UNITED STATES PATENT AND TRADEMARK OFFICE

10/567,891

Office Action Summary	Application No. 10/567,891	Applicant(s) VON SPRECKELSEN ET AL.	
	Examiner ROBIN HYLTON	Art Unit 3781

DETAILED ACTION

**FIG. 13*****Allowable Subject Matter***

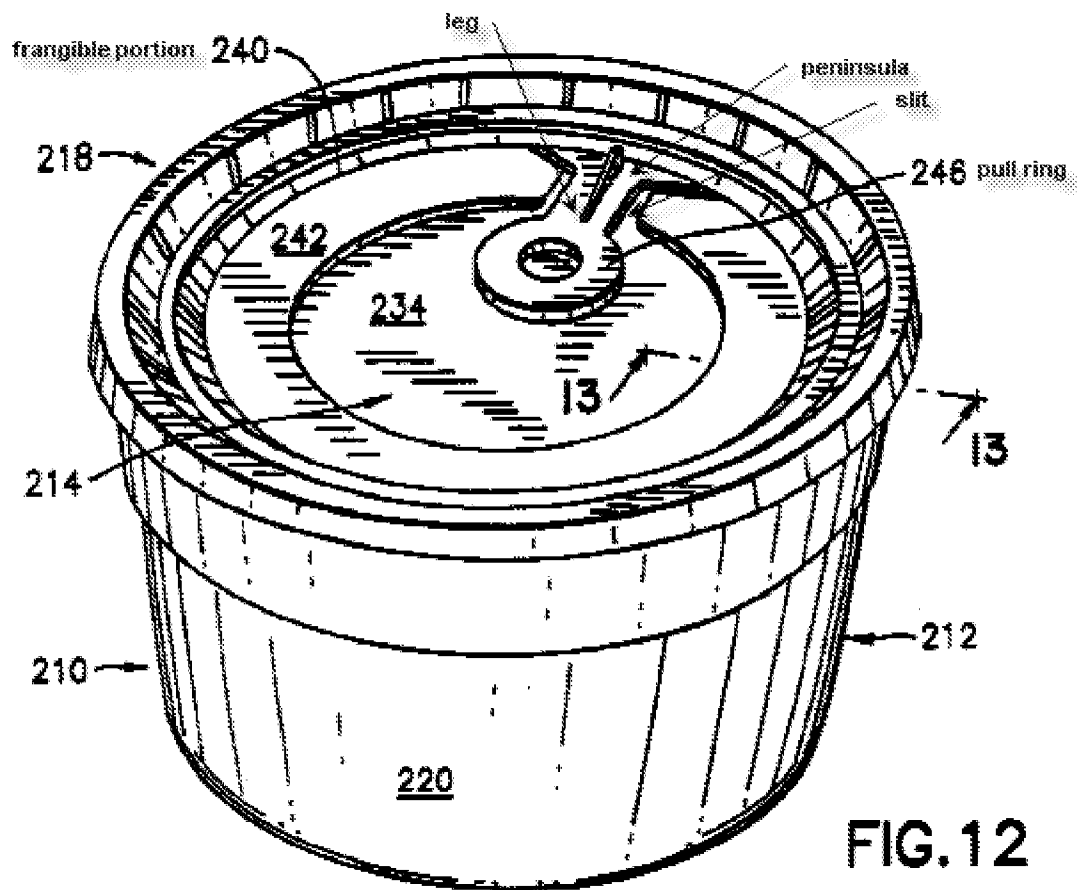
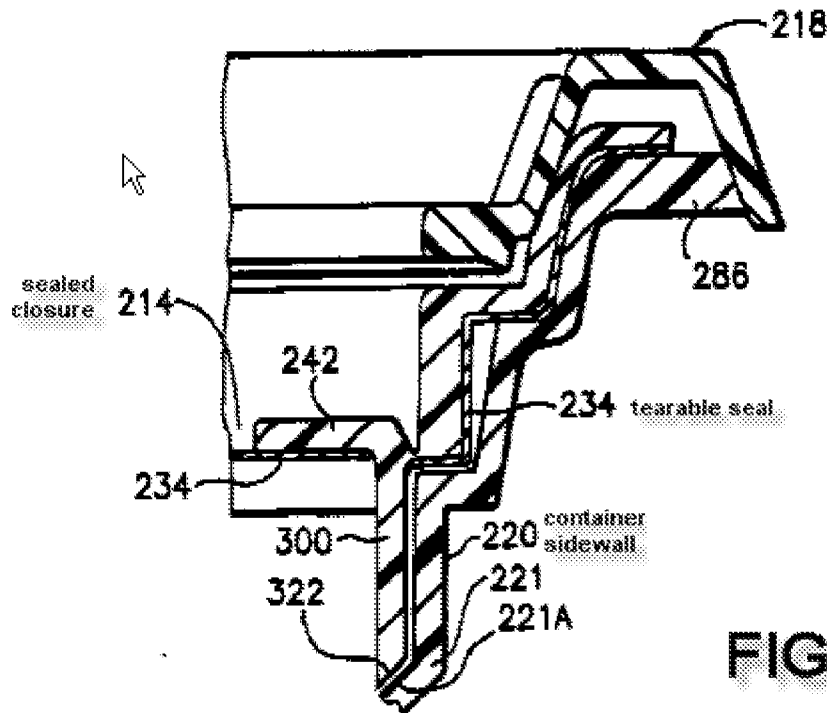
10. Claims 10, 11, 14, 20 and 21 are rejected under 35 U.S.C. 102(b) as being anticipated by Farrell et al. (US 5,692,635). See figures 12 and 13 and column 8, lines 43-48. Figure 12 is re-produced below and labeled as per the examiner’s interpretation of the claim language. The

tearable seal (234) is seen in figure 13.

Regarding claim 14, the seal is weldable on both sides although it is not welded to the container.
